5571 TAB PUNCH LIST

Prepared by Ben Searles

May 8, 2025

#173 [UNIT 506] [NEW] Equipment GFI outlets.

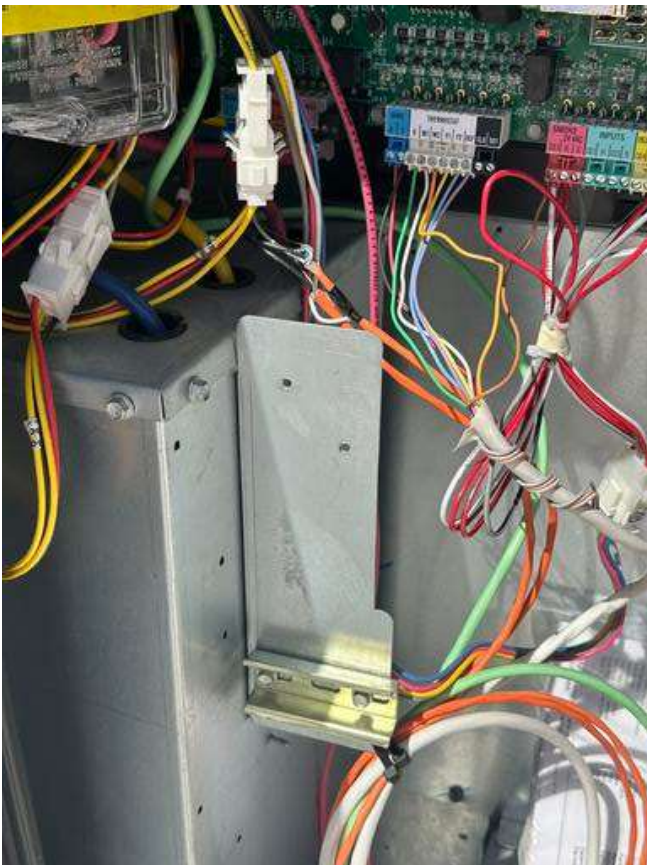
AC4 GFI outlet missing. All other units have GFI's installed and powered.
